SUBJECT: Forwards Westinghouse Field Change Notice CQLM-10593 re mods to solid state logic protection sys necessary to eliminate potentially undetectable test circuit failure. Info completes response to SER Confirmatory Item 16.

SHEARON HARRIS NUCLEAR POWER PLANT  
UNIT NO. 1 - DOCKET NO. 50-400  
SOLID STATE LOGIC PROTECTION SYSTEM TEST CIRCUIT

FCN NUMBER  
CQLM-10593  
SHOP ORDER NUMBER  
CQL-387

SUBJECT: Modify the Solid State Protection System (SSPS) output relay test panel for Shearon Harris to insure detection of a potentially undetectable test circuit failure.

1083HG1 E 7

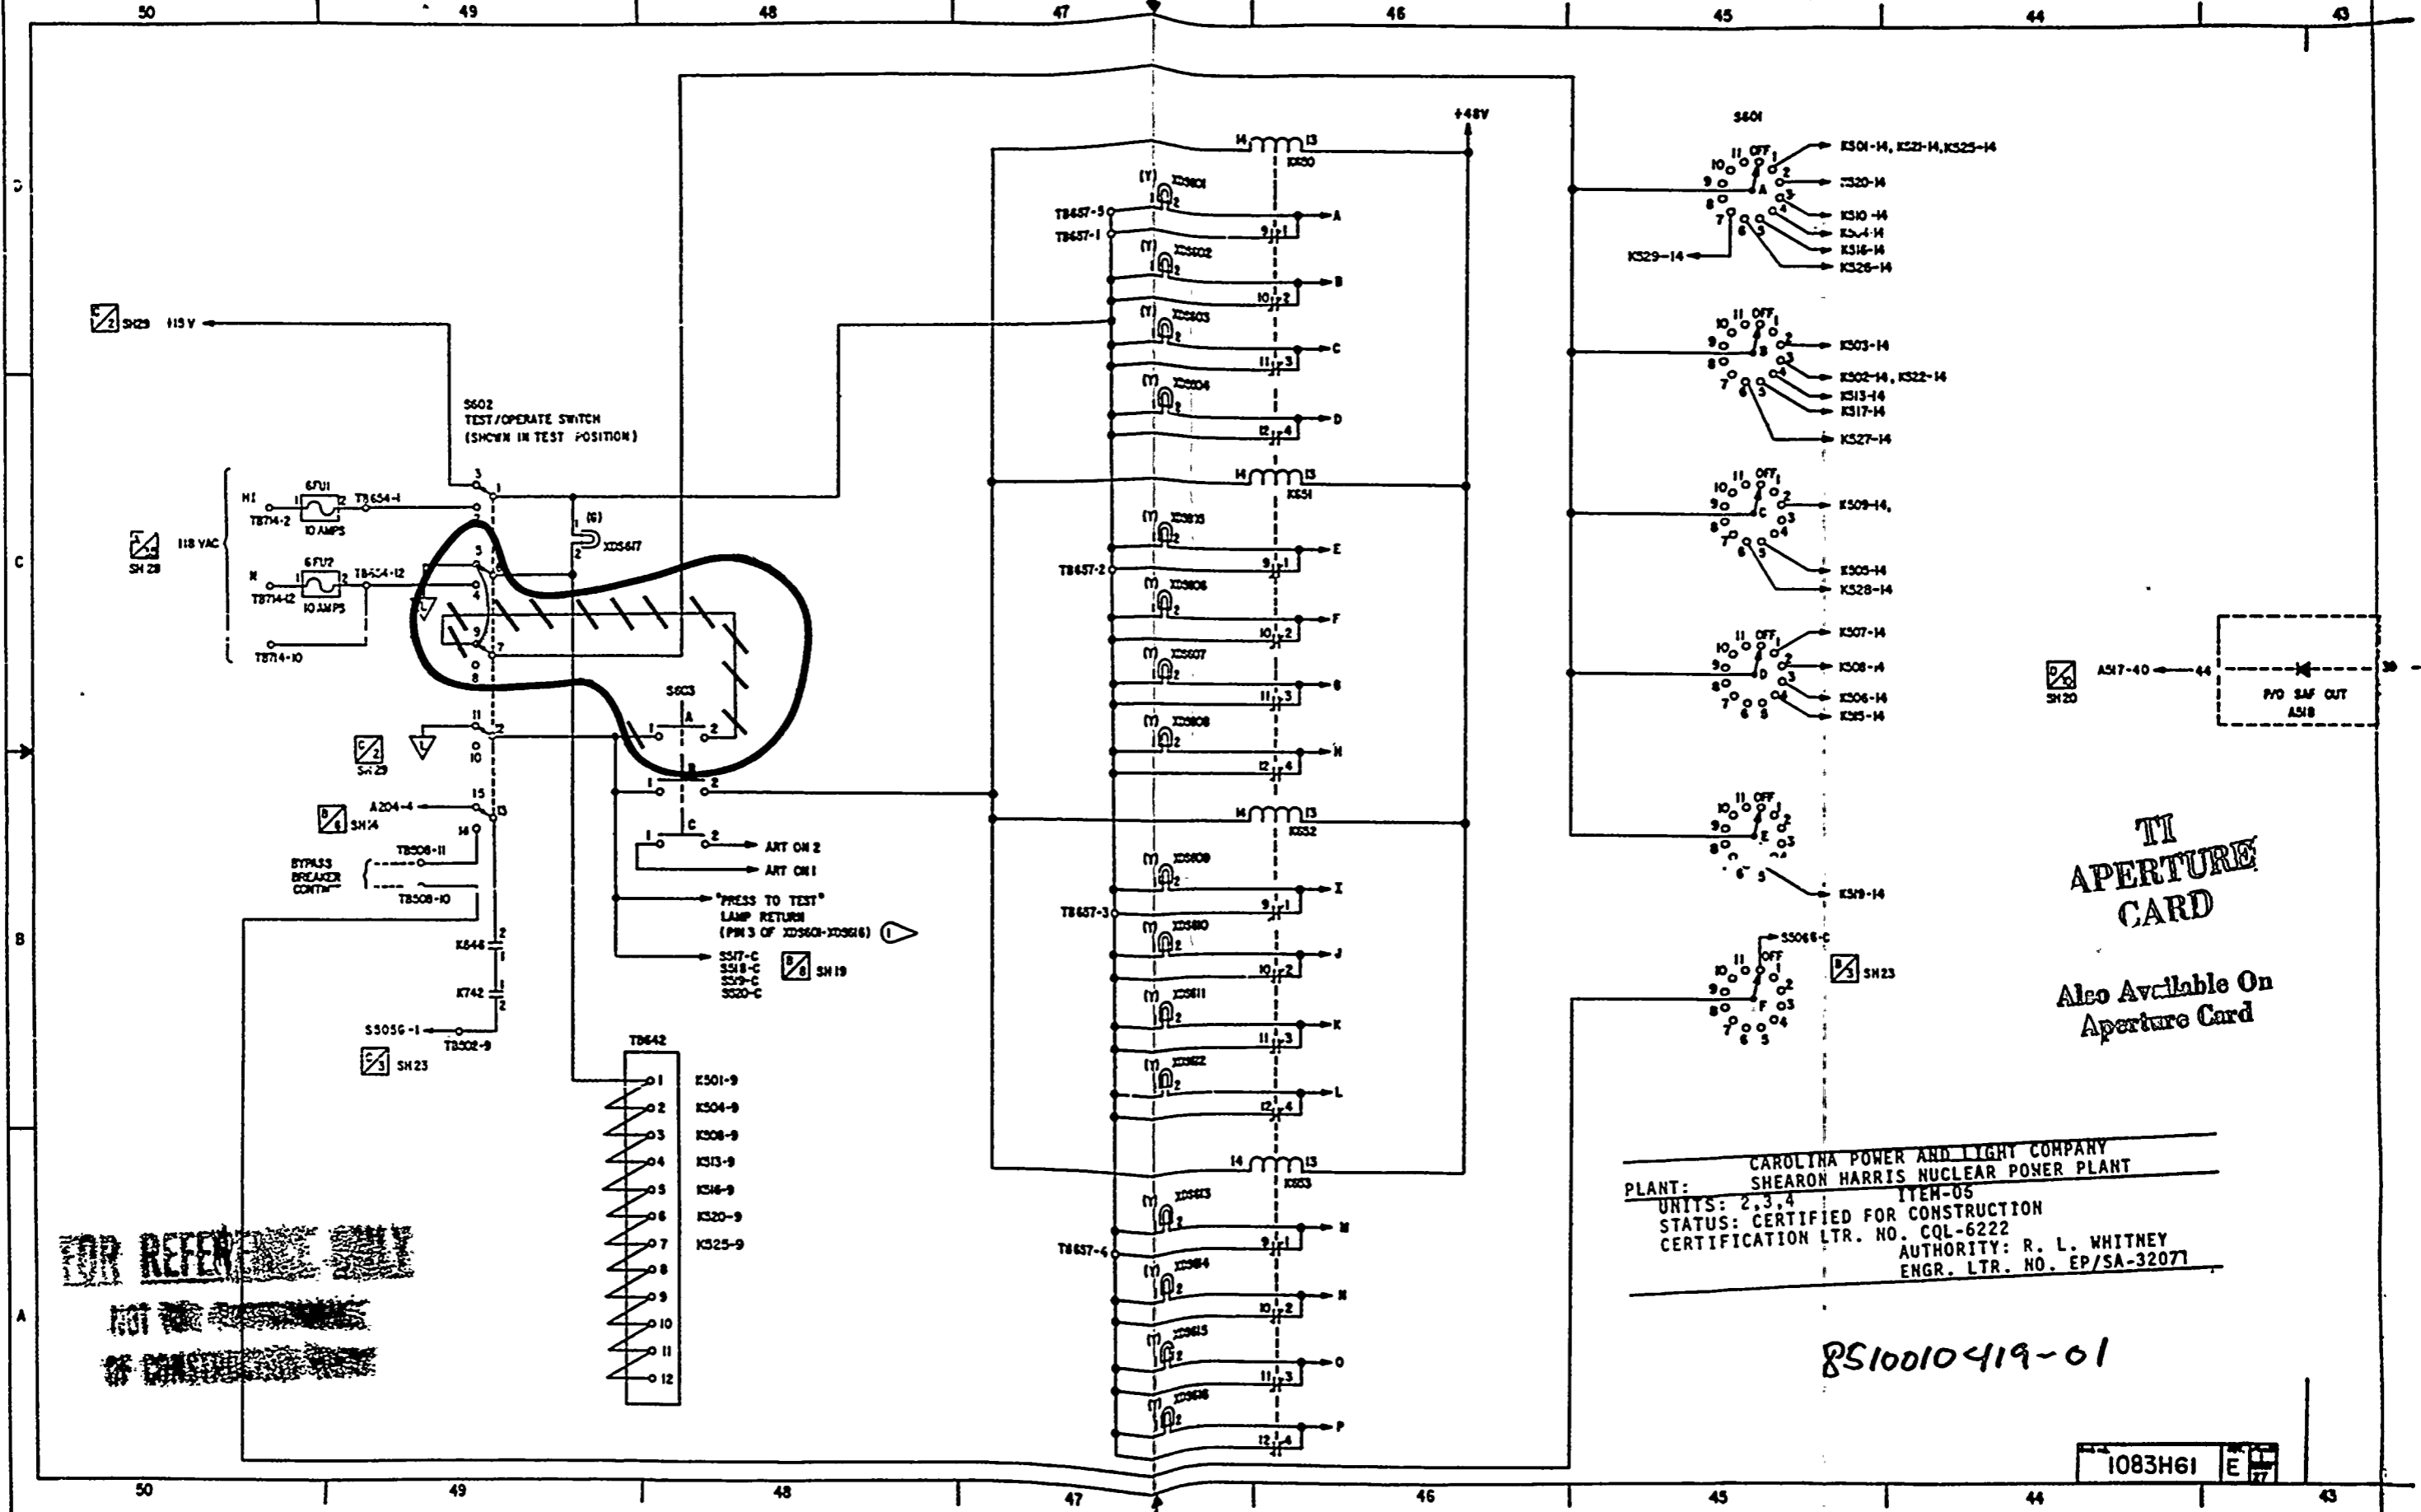
REFERENCE DRAWINGS: The following attached drawings have been marked to reflect the necessary information to complete this change. Revised schematic and wire list will be formally transmitted at a later date.

- Wire List - Output Relay Test Panel 2380A48 Sheet 18 Rev. D  
Sheet 19 Rev. D
- System Schematic - 1083H61 Sheet 27 Rev. E
